marantz® SERVICE BULLETIN		Date: 27-Feb.-2004	Model: DV8400
		Page: 1 / 1	REF.NBR: MZ04-017
Circulation:		Subject:	
Application:		Output signal distortion.	
x for information customer complaint in case of service mandatory			
		See Below

marantz® SERVICE BULLETIN		Date: 15-May-2003	Model DV8400
		Page: 1/1	REF.NBR: MZ03-016
Circulation:		Subject:	
Application:		1. Slow mode problem	
x for information customer complaint in case of service mandatory		2. RC232C command problem in the condition of "No Disc."	
Before MZxxxxxx02xxxx		Int.ref:

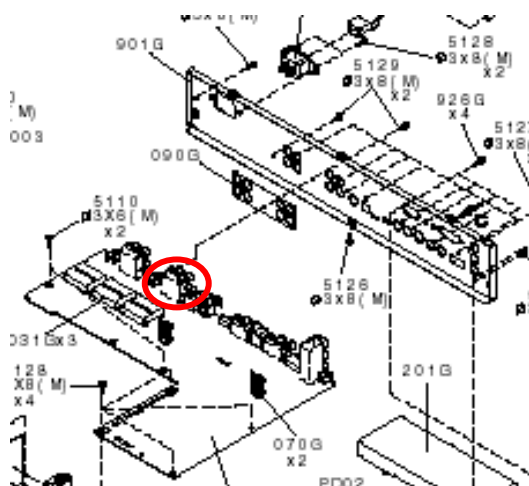
- 1) FRONT L/R 1 2 and SURR.L/R, CENTER L/R, SUB W L/R of AUDIO OUTPUT are simultaneously Connected to amplifier.
- 2) If the Amplifier which used the electronic switch is turned off, another sound will be distorted.

FRONT L/R 1 2 are connected parallel, therefore, if the Amplifier input of another side short-circuits, it will influence

On the PM01-AV CIRCUIT BOAD

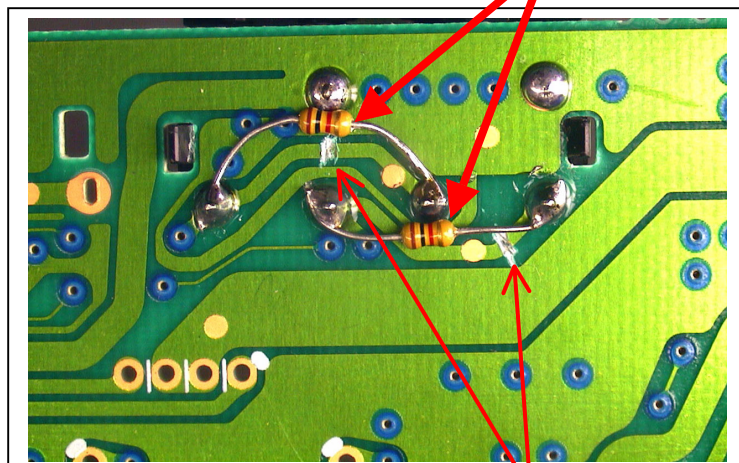
1. Resistor 1k ohm is added to 2 of FRONT L/R 1 2.
2. Cut pattern.

Solder side of FRONT L/R 1 2 (Jack RCA) 1 k ohm

Cut pattern

Carbon film fixed resistor, 1k ohm +5% 1/6W (part no. **GD05102160**)
